## **Customer Service Bulletin SD800008 Cable Issues in SE125W/250W Rack Mount Transmitters**

**Application:** This bulletin applies to **SE125 and SE250 Transmitters SLF3310 and SLF33030**. This applies to SE transmitters shipped prior to February 15, 2013.

Example #1 - 9C012047 Cable Replacement, SE 125W/250W Rack Mount Dual Transmitters):

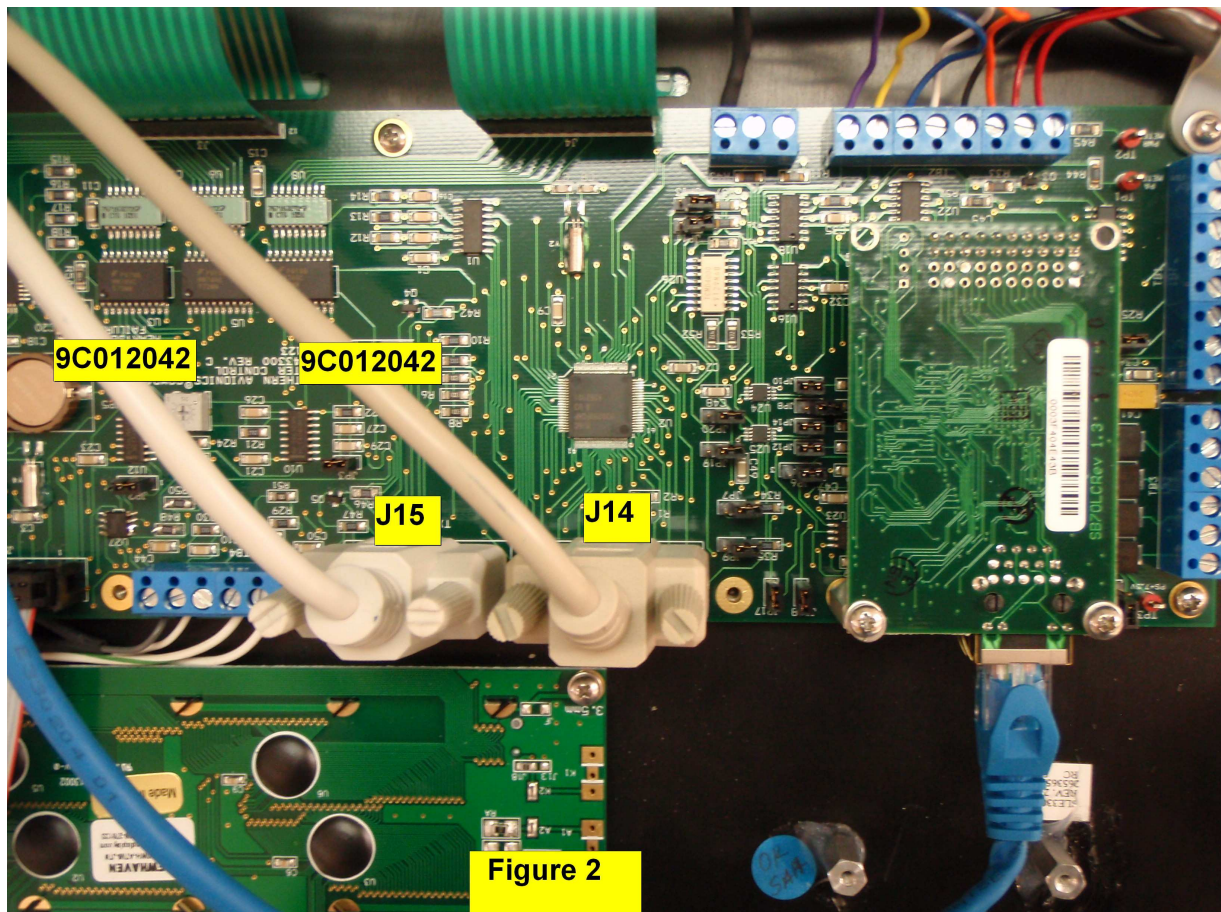
- Disconnect the 9C012047 cable from J2 on the SPA PCB (SLP46000 in the SE125W transmitter, or SLP48000 in the SE250W transmitter). Do this at 1A1A4 on Transmitter #1 and 4A1A4 on Transmitter #2.
- Disconnect the other end of the 9C012047 cable from J1 on the SLP45200 Filter Bridge PCB in both transmitter units, 1A1A5 on Transmitter #1 and 4A1A5 on Transmitter #2.
- Install replacement cables 9C012065 in place of both cables removed.

Example #2 - 9C012042 Cable Replacement, SE 125W/250W Rack Mount Dual Transmitters):

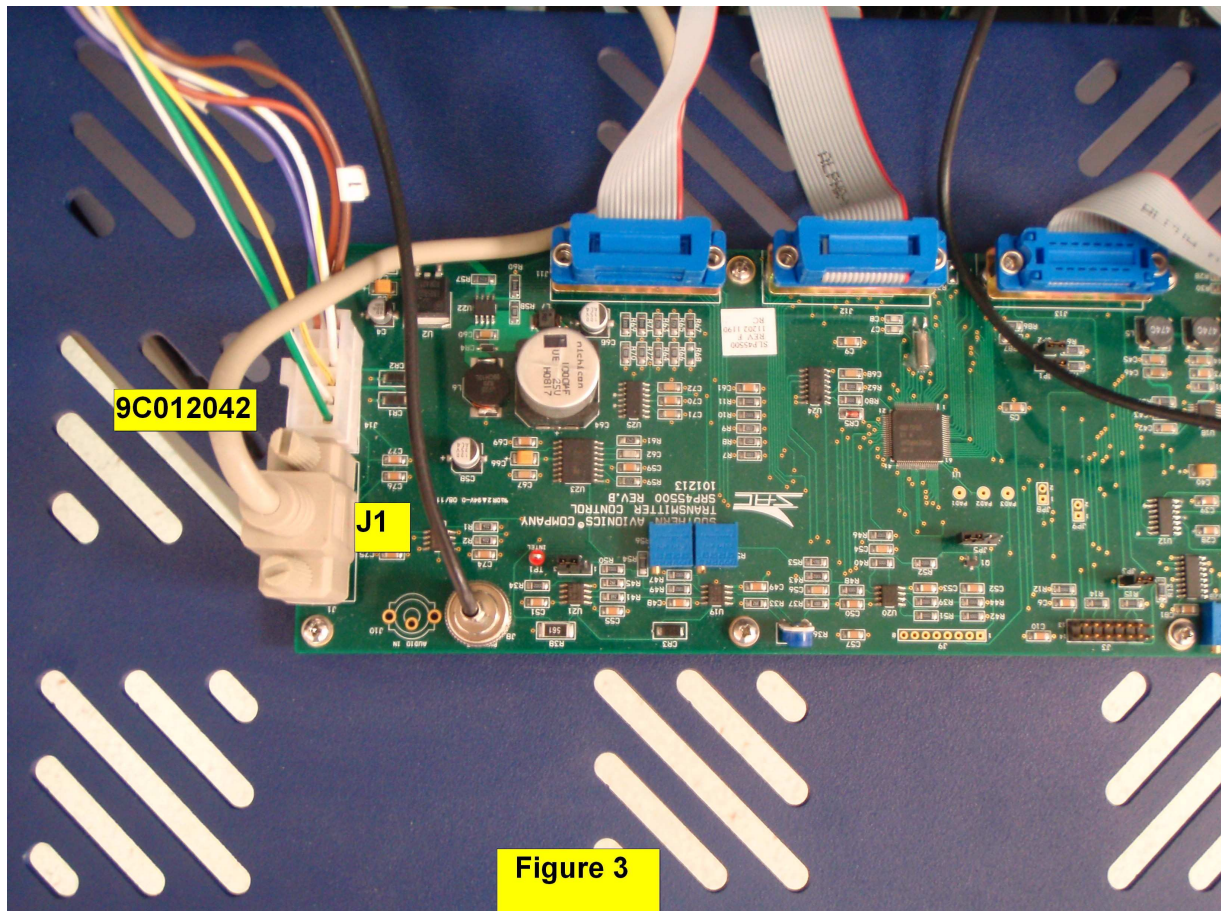
- Disconnect the 9C012042 cable from J14 on the SLP43300 Master Control PCB 5A1A1 per Figure 2.
- Disconnect the 9C012042 cable from J15 on the SLP43300 Master Control PCB 5A1A1 per Figure 2.

- Disconnect the 9C012042 cable from J1 on the SLP4550 Transmitter Control PCB on Transmitter #1 (1A1A1) per Figure 3.
- Disconnect the 9C012042 cable from J1 on the SLP4550 Transmitter Control PCB on Transmitter #2 (4A1A1) per Figure 3.
- Install replacement cable 9C012061 in place of the cable removed at J14 and J1.
- Install replacement cable 9C012061 in place of the cable removed at J15 and J1.
- Secure cables in place with tie wraps provide.
- Dispose of cables per local standards.
